Discuss and take appropriate action on Change Order #6 for Williamson County Regional Park.

RE: Williamson County Regional Park

Change Order #6

1 ELEVATION (REF. 3/A3.5)
SCALE: 1/8" = 1'-0"

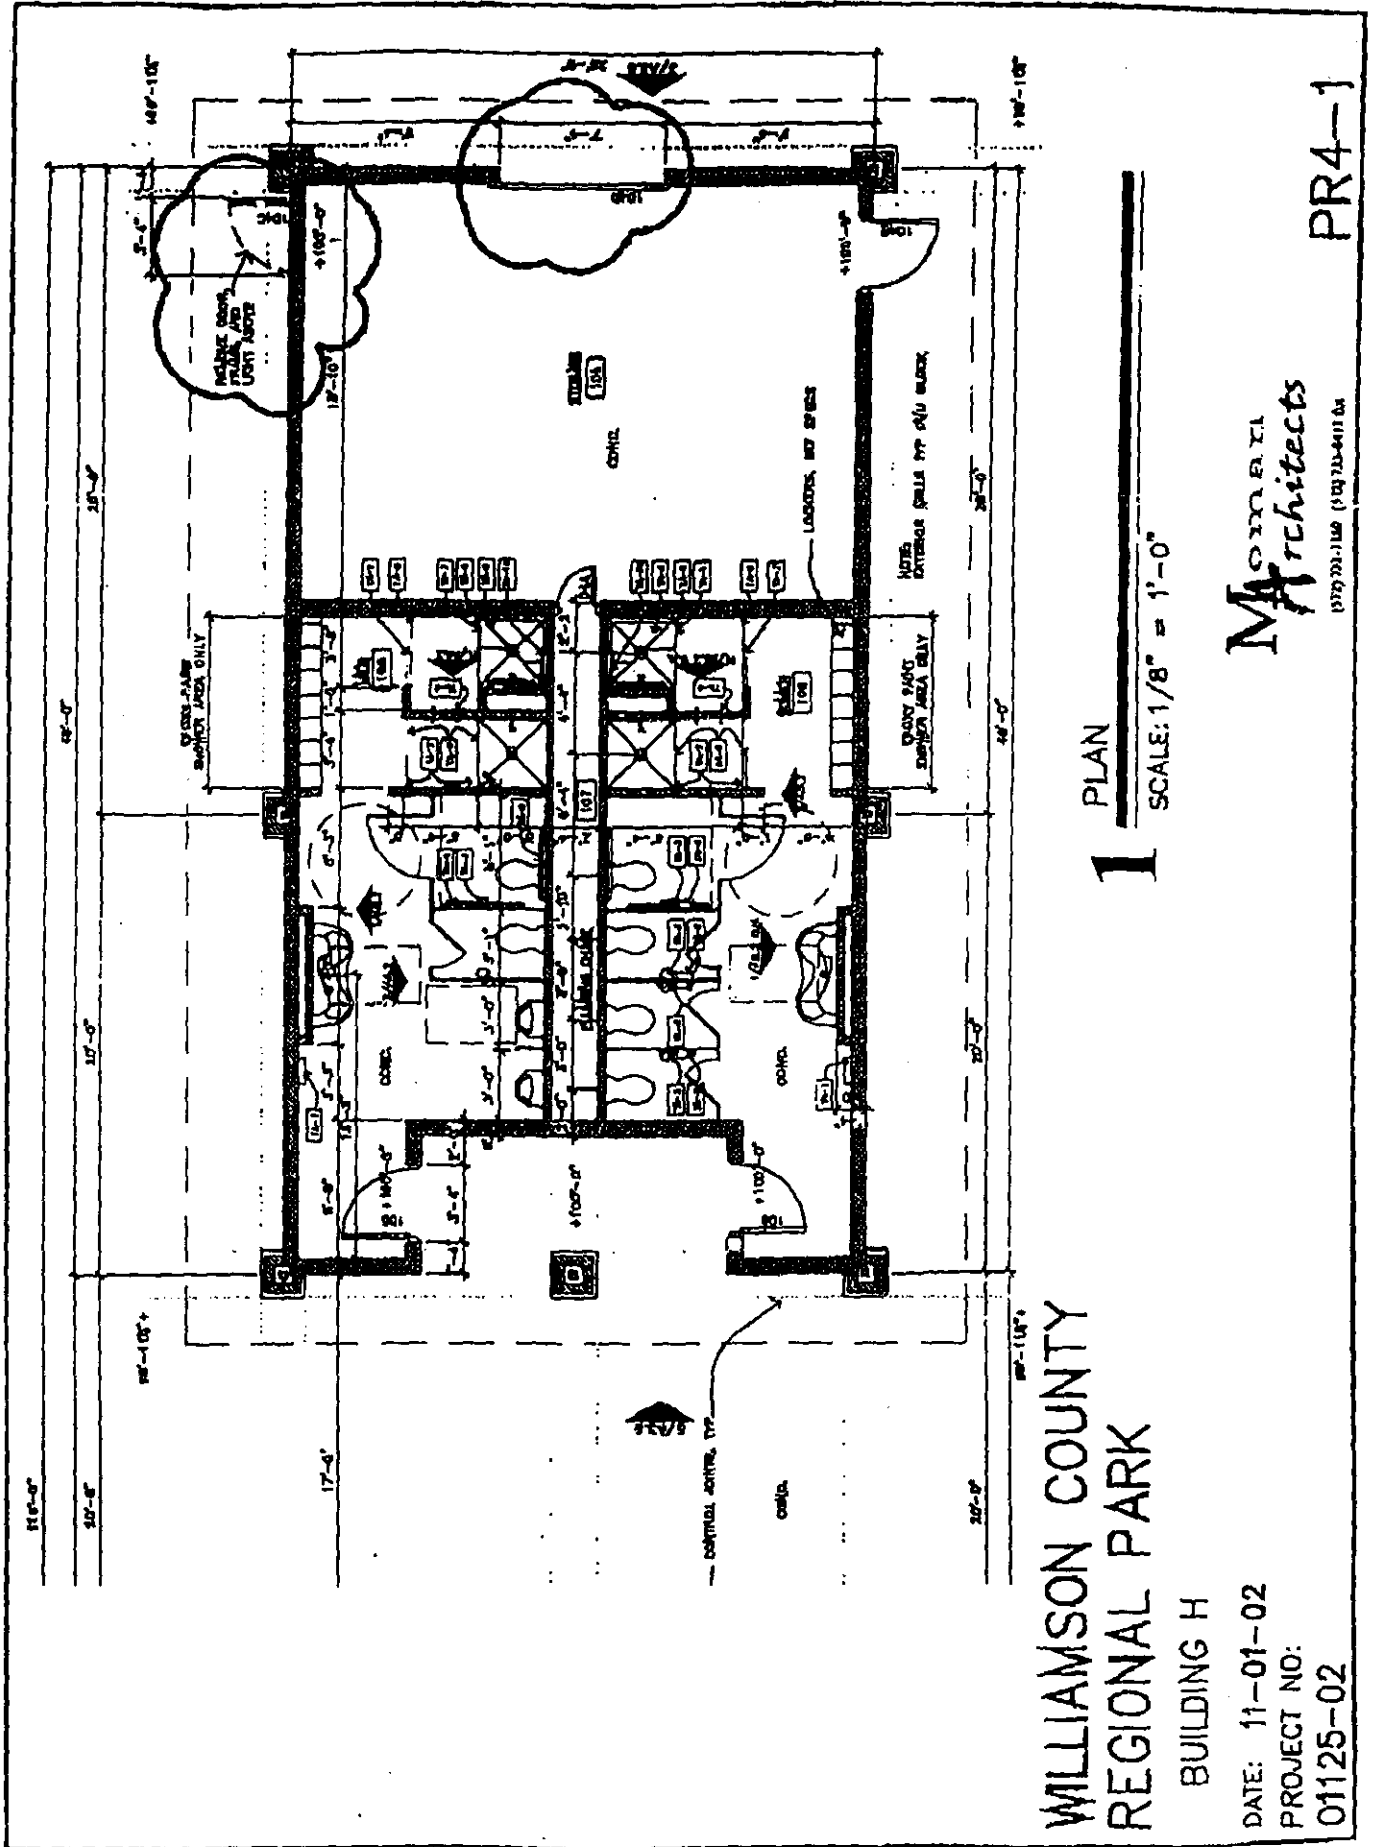
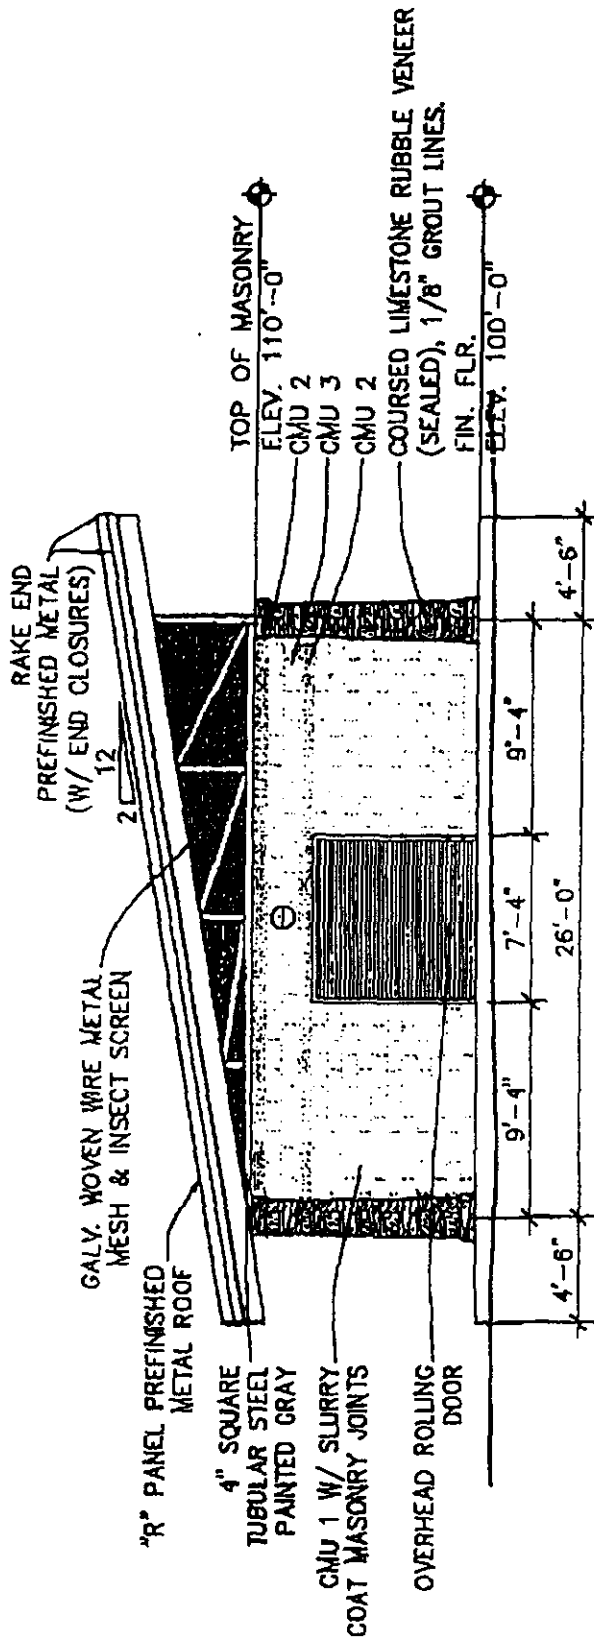
This change incorporates installing one additional coiling door in Building H at the Williamson County Regional Park project. This price includes: all labor, material, equipment, and incidentals required for complete coiling door installation; deleting one (1) hollow metal door, frame, hardware and installation. Coiling door shall be installed per Moman Architects details dated 11/1/02. Coiling door to be manually operated with thumbturn locks, typical of countertop doors. Mesh partition shall be provided and installed typical to those being installed in Building C & E and as shown on Moman Architects supplemental details dated 10/24/02. Mesh partition to be fabricated and installed in three sections. All metal shall be painted gray to match building paint color. Please see attached.

| DOOR # | FRAME | | DOOR | | | | | | DETAILS | | | | | REMARKS | |
|--------|--------------|-----------------------|---------------|-----------|------|--------------|-------|--------------------|--------------------------------|--------------------------------|--------------------------------|--|----------------|-------------------|--|
| 104D | X | | 7'-4" X 7'-4" | 1 3/4" | - | | | | S1:4 | S2:4 | S3:4 | | • | NEW OH DOOR | |

CHANGE ORDER

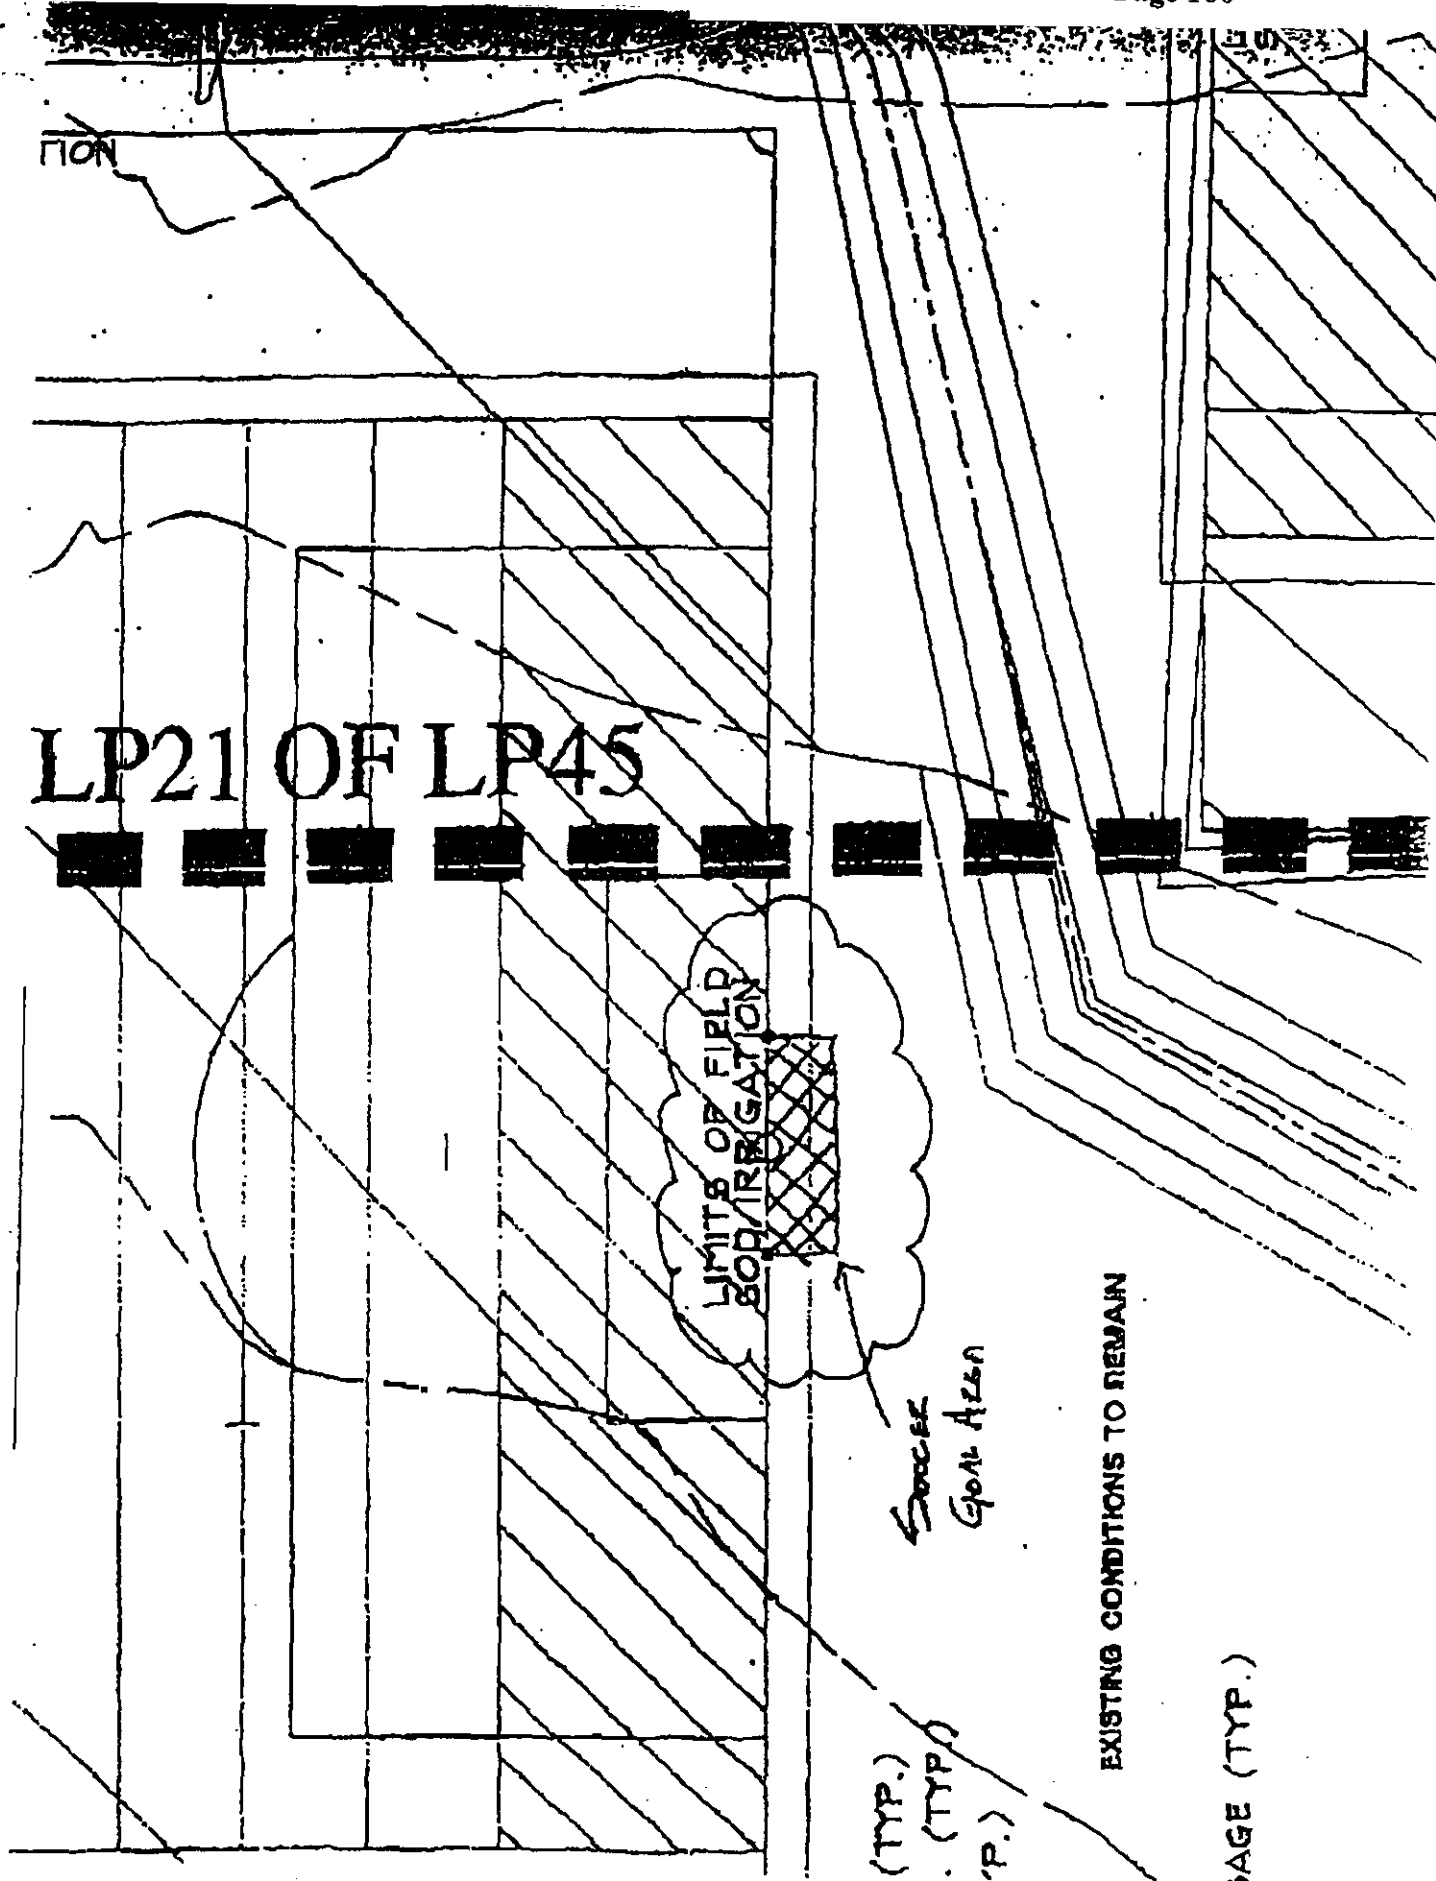
Sod Inside Goal Posts on Soccer Fields - 1-5 and 7-11 ^{COMMON} ^{TIF}

10 x 25 Each = 250 Square Feet Each Goal ^{OK}
 2 Goals Per Field
 10 Fields x 500 Square Feet = 5,000 Square Feet
